Central Valley Regional Water Quality Control Board

ORDER AMENDING CLEAN WATER ACT SECTION 401 WATER QUALITY CERTIFICATION AND ORDER FOR UNION PACIFIC RAILROAD (UPRR), UPRR VALLEY SUBDIVISION MILE POST 310.34 BRIDGE REPLACEMENT PROJECT (WDID NO. 5A45CR00595A2), SHASTA COUNTY

Figure 2. Project Impacts Map

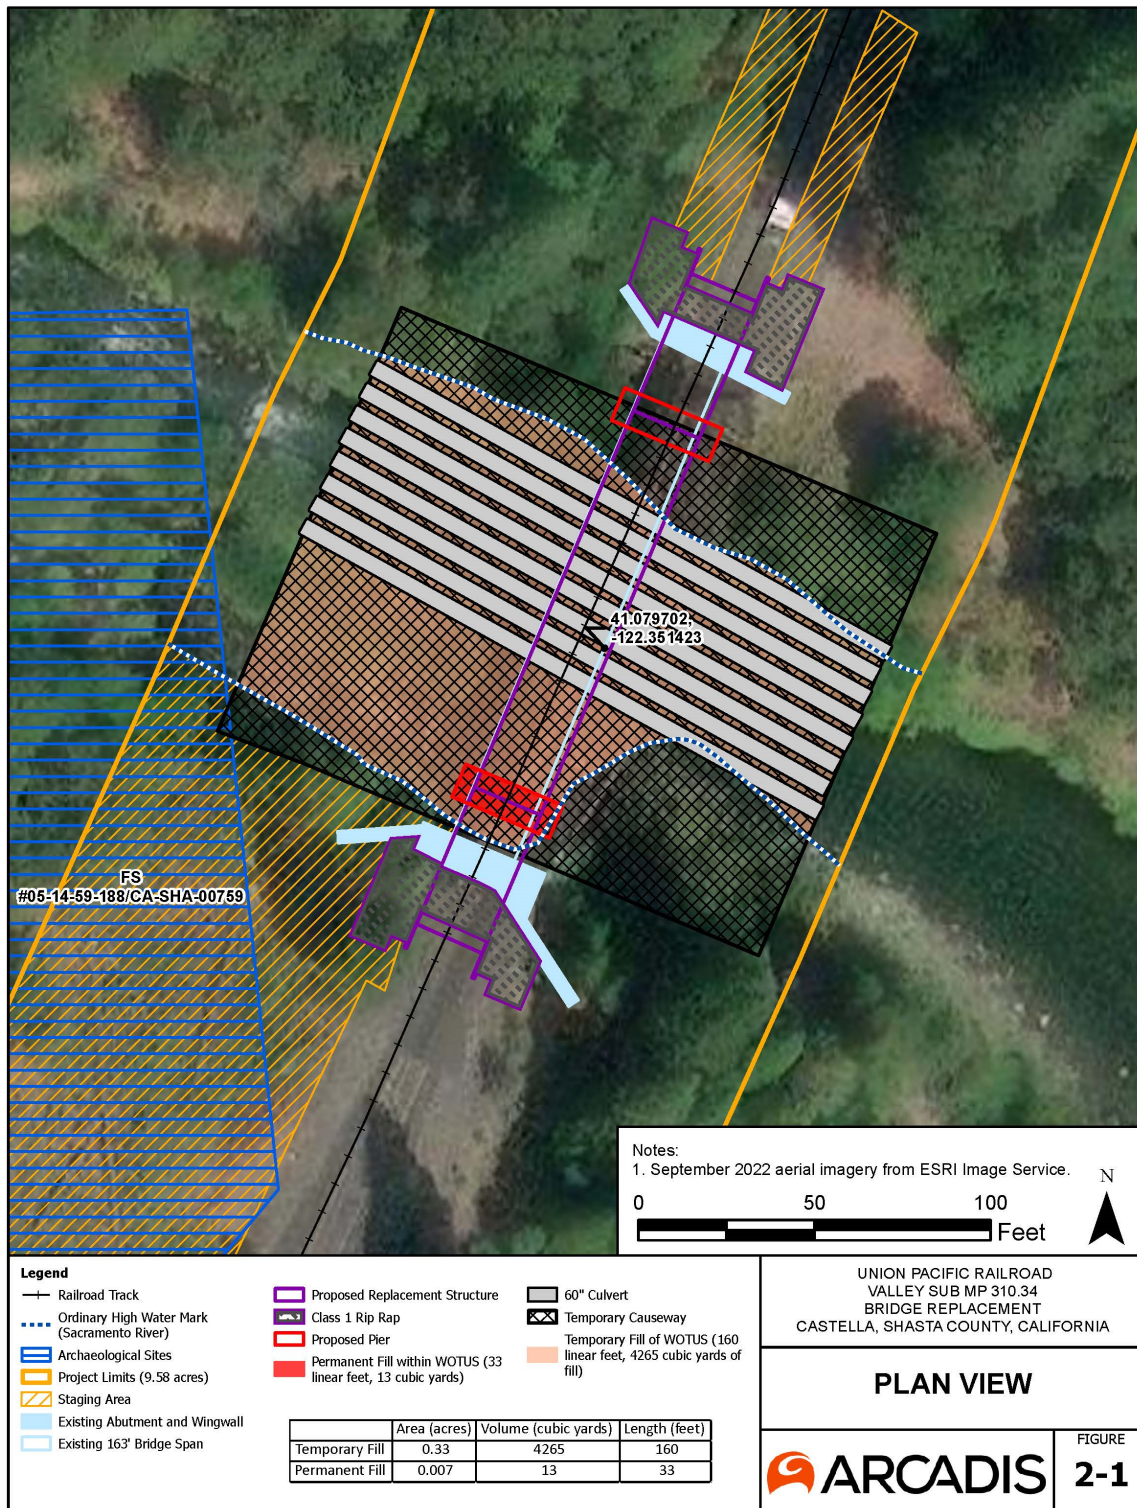
Union Pacific Railroad Company is requesting an amendment to the Section 401 Water Quality Certification and Order to expand the temporary causeway and include an alternative temporary construction work bridge in the event that river flows are too high to be accommodated by the causeway. The expansion will increase the temporary impacts from 2226 cubic yards to 4265 cubic yards, and 142 linear feet to 160 linear feet.

Therefore, Section IV, Project Description; VII, Description of Direct Impacts to Waters of the State and Table 1; Attachment A, Figure 2; and Attachment B, Table 2 are amended in underline format below.
